## The Progress Power (Gas Fired Power Station) Order

# APPLICATION TO MAKE A NON MATERIAL CHANGE TO THE PROGRESS POWER (GAS FIRED GENERATING STATION) ORDER

**PINS Reference Number:** EN010060  
**Document Reference:** NMC  
**Regulation Number:** Regulation 4  
**Author:** Progress Power Limited

FIGURE 1 – SITE PLAN

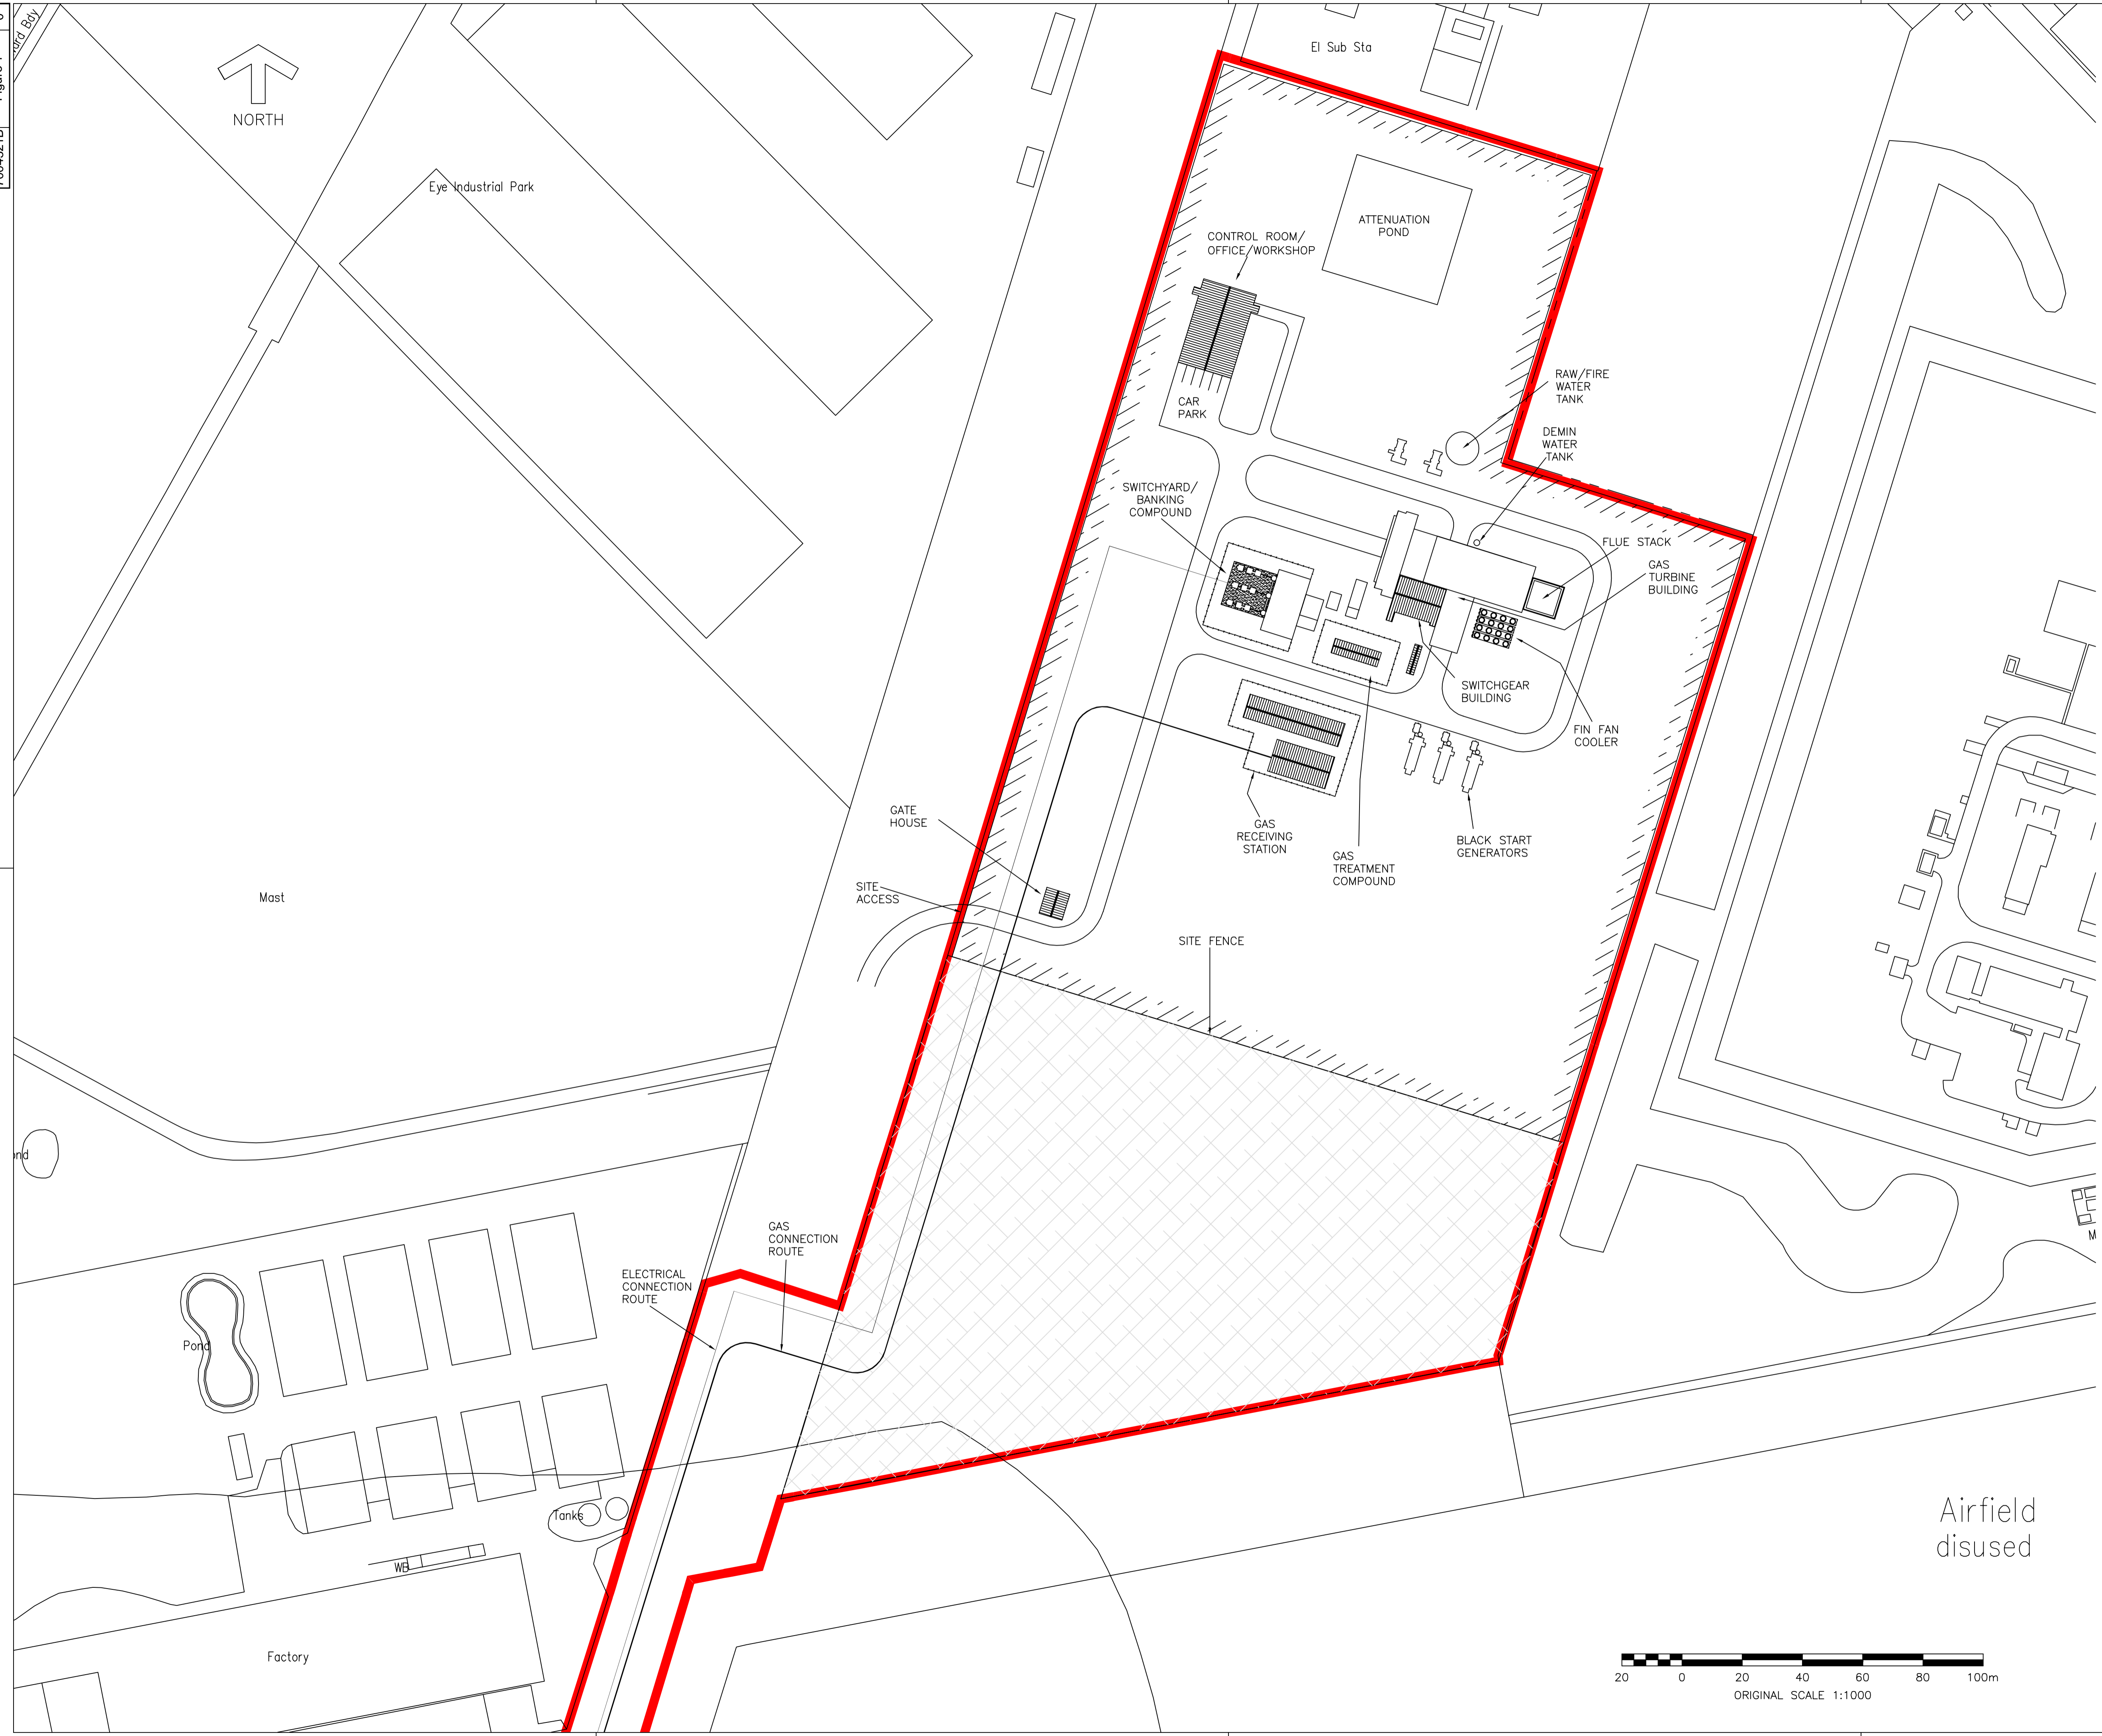
Figures 1, 2, 4, 5 and 6 of the Environmental Report show the proposed single GTG scenario and the proposed changes. The screening exercise set out in Chapter 4 of the Environmental Report identifies the potential for a change in the environmental effects predicted in the Environmental Statement (“**ES**”) for landscape and visual effects and air quality.

Figures 1, 2, 4, 5 and 6 of the Environmental Report show the proposed single GTG scenario and the proposed changes.

Figures 1, 2, 4, 5 and 6 of the Environmental Report show the proposed single GTG scenario and the proposed changes.

Figures 1, 2, 4, 5 and 6 of the Environmental Report show the proposed changes.
